From: Mitman, Jeffrey *in reply*
Sent: Sunday, January 09, 2011 5:42 PM
To: Wescott, Rex
Cc: Ferrante, Fernando
Subject: RE: ~~QUO - Sensitive Information~~ -- APOB Jocassee Hydrograph

Subject: ~~OUO - Sensitive Information~~ -- APOB Jocassee Hydrograph

The first Excel tab shows the hydrograph. The current spreadsheet values should mimic the "Law" hydrograph (from Jocassee Dam Hydrologic Analysis by Law Environmental, dated January 1991 as updated through 6/16/2009). It can easily be tweaked to show different scenarios by changing the cells highlighted in red. These red cells are setup to allow different what-if analysis. For example if one turbo-generator is unavailable, change the value labeled "Turbine-Generators Available" from 4 to 3. The 72 hours PMF has been subdivided into 4340 time-steps, each of about 1 minute. Therefore, once a change is made, the spreadsheet will take a second or two to recalculate and display the new results.

Jocassee Spillway Rating

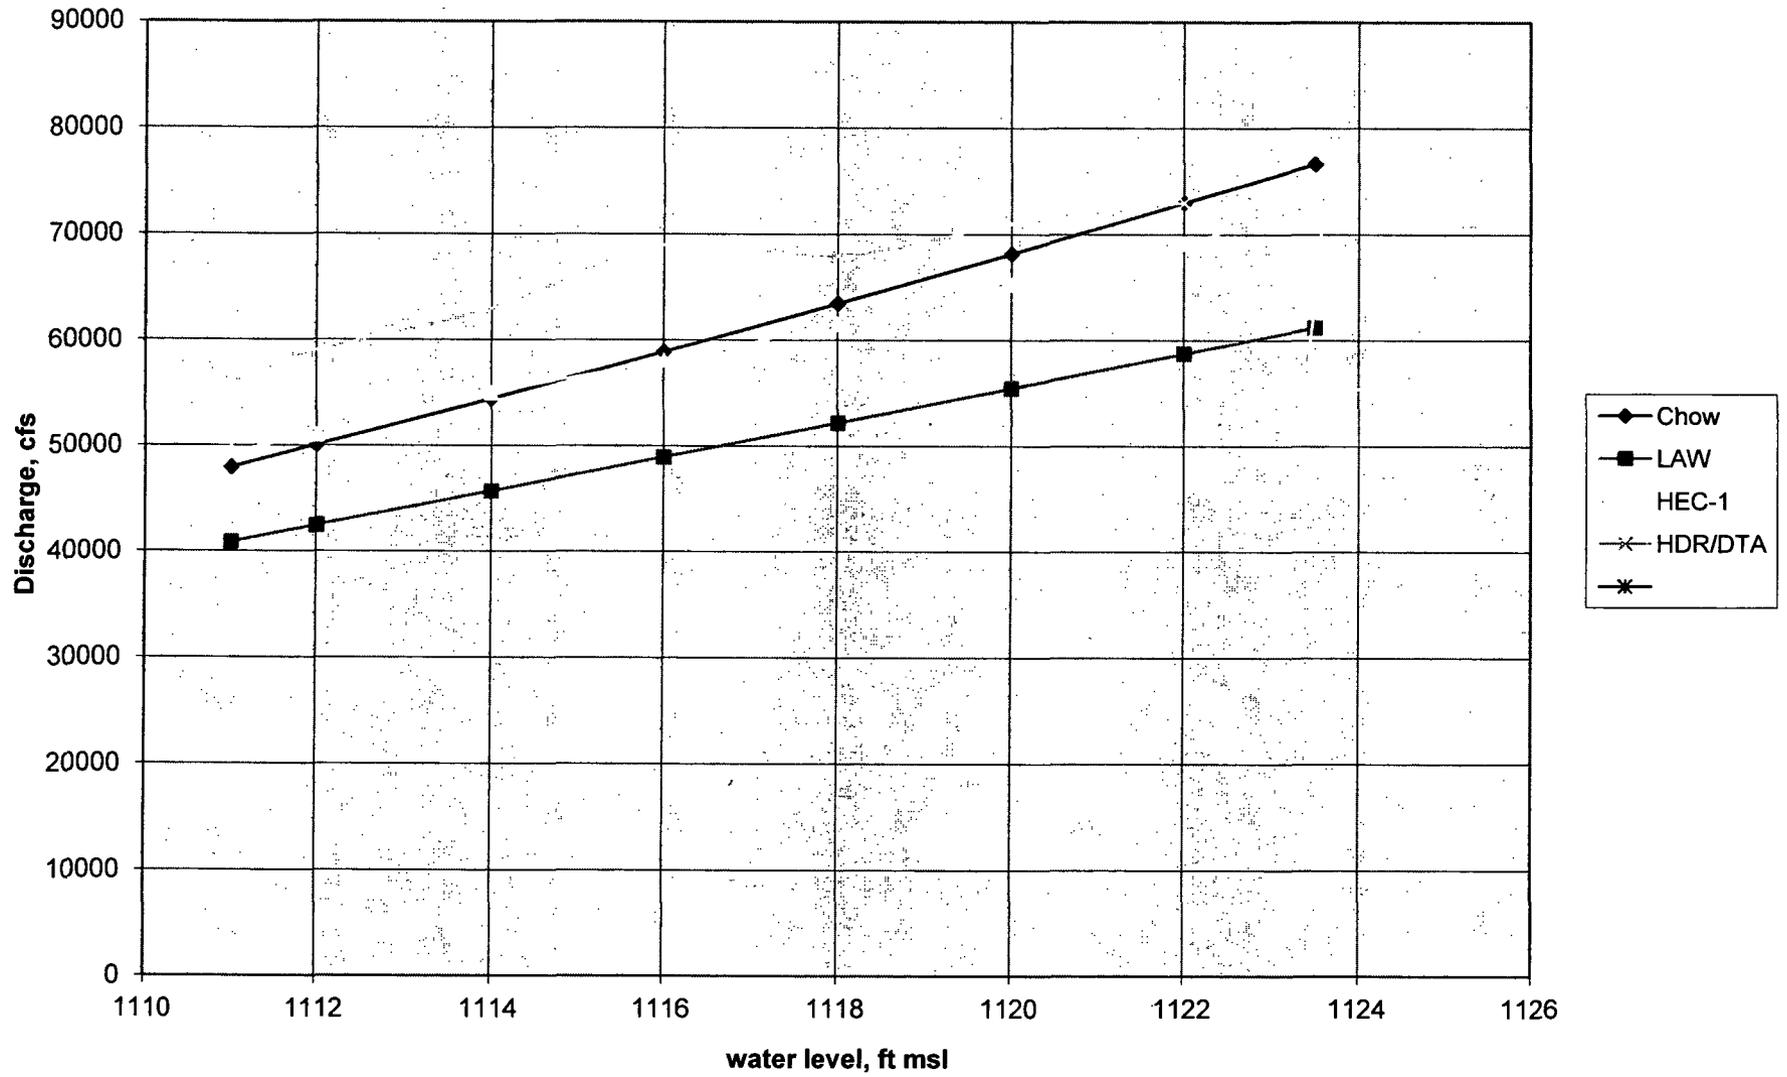
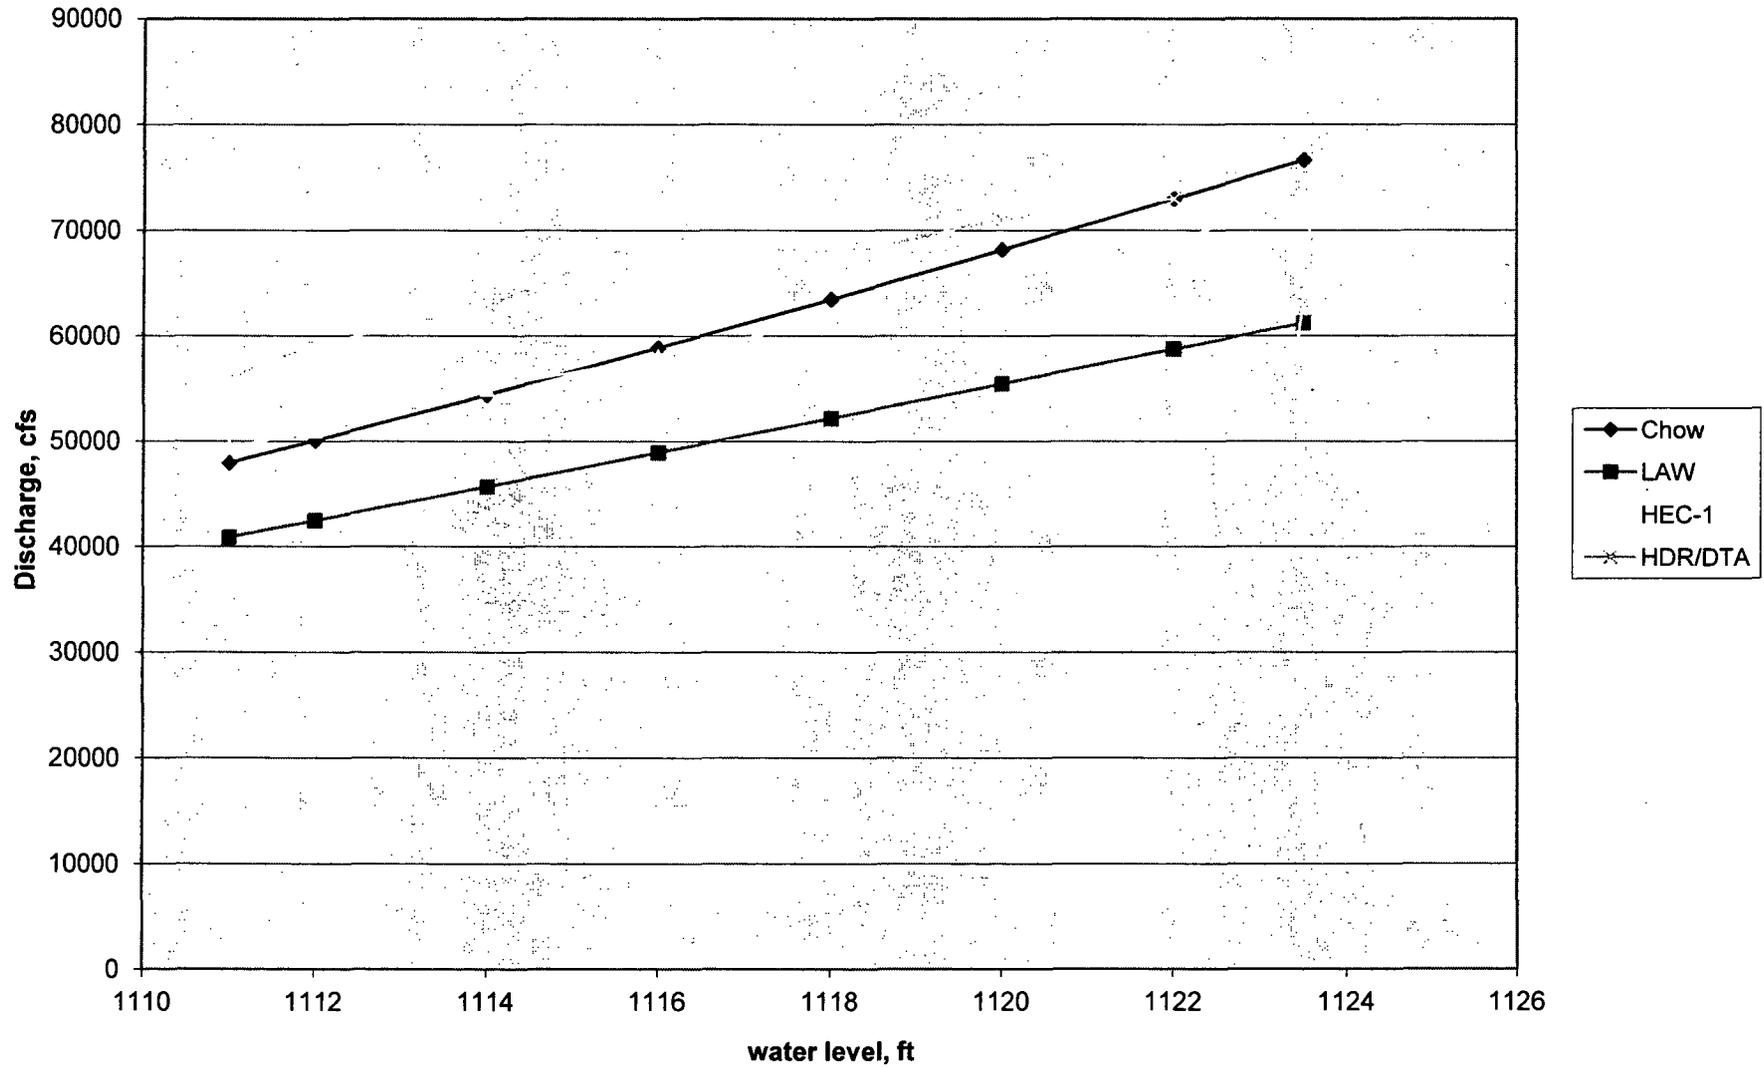
3. I've added the capability to what-if a failure of one or both of the spillways to open. There are spreadsheet switches to model these scenarios. Under these conditions I've assumed that each unopened spillway will overtop when level exceeds 1110 ft. msl as that is the physical top of the spillway. The flow across the top of an unopened spillway is a swag on my part, I've assumed the flow would mimic an opened spillway with a bottom elevation of 1110. It's not accurate, it's probably non-conservative (i.e., it gives too much credit) but it should be reasonably close and much better than assuming the unopened spillway passes no flow.

5. I've added the capability to explore both "30" and "38" foot wide spillways. The base analysis was performed with a 30 foot spillway. If a 38 foot spillway is used, the results change moderately. I'm not convinced that 38 ft. spillways is appropriate (or inappropriate) because Duke has not provided a bases for the wider value. Likewise, the spillways analysis does not take into consideration that there is a bridge across the top of the spillways starting at ~1123.5 ft. A more accurate calculation would take this bridge into account and change the flow from a "weir" model to an "orifice" model at high reservoir levels. Ignoring the bridge is somewhat non-conservative by increasing the spillway capacity if the level should approach the top of the spillway.
